HITACHI MICROCOMPUTER TECHNICAL UPDATE

DATE	25 January 2001	No.	TN-SH7-272A/E
THEME	Bug of a serial data reception of the multiprocessor communication function at SCI

CLASSIFICATION	☐ Spec change ☐ Supplement of Documents	■ Limitation on Use	
PRODUCT NAME	HD6417750 ,HD6417750S ,HD6417751	Lot	Lot #All

Fig.1 A sample of a flowchart of a multiprocessor serial data reception

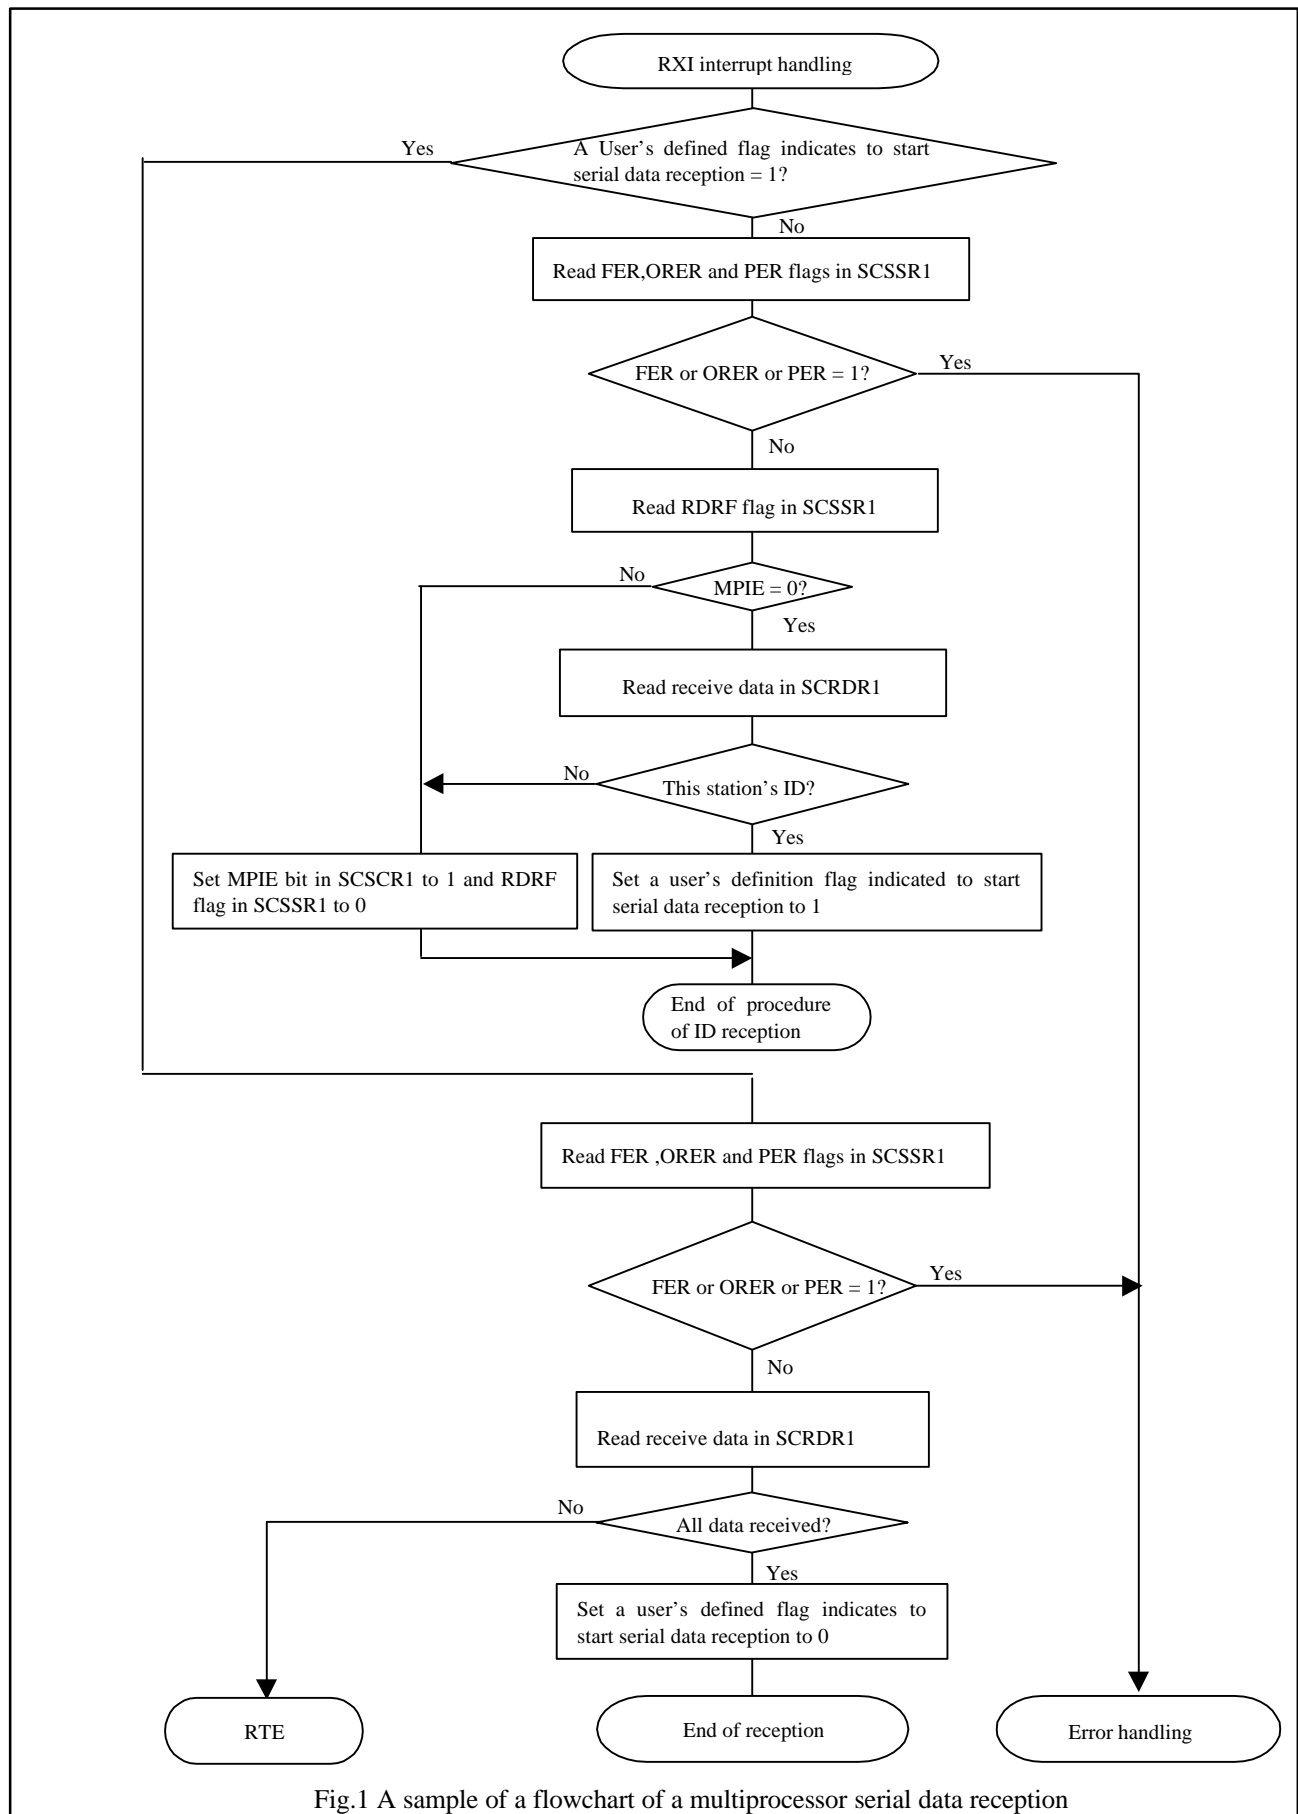
(1) SCSSR1.RDRF flag is set to 1 in the multiprocessor serial data reception after received a frame of data for another station even if SCSCR1.MPIE bit equals 1(the multiprocessor interrupt enabled).

(2) The value of SCSSR1.MPB bit is not correct.

(3) The flags, FER and ORER, can be set to 1 even if SCSCR1.MPIE bit equals 1.

Use the following procedure for a serial data reception of the multiprocessor communication function.

(1) The procedure to distinguish the multiprocessor interrupt from the SCI interrupt

Please check the value of SCSCR1.MPIE bit in the interrupt handler, when a SCI interrupt request occurs on the multiprocessor serial data reception.

Case 1: SCSCR1.MPIE bit equals 1

A received data should be ignored.

Although the received data is for another station's (MPB=0), SCSSR1.RDRF flag is set to 1.

Please clear SCSSR1.RDRF flag to 0 in the RXI interrupt handler.

Case 2: SCSCR1.MPIE bit equals 0

This case is the multiprocessor interrupt request or the RXI interrupt for a reception of this station's data.

(2) The procedure to distinguish the received data is "ID" or "data".

Don't use SCSSR1.MPB bit for the processing of software.

In the processing of software to distinguish a receive data between this station's ID (MPB=1) and a valid data (MPB=0), please create a user's defined flag on a memory which indicates information about starting a serial data reception.

A sample of a flowchart of a multiprocessor serial data reception is shown in the following.
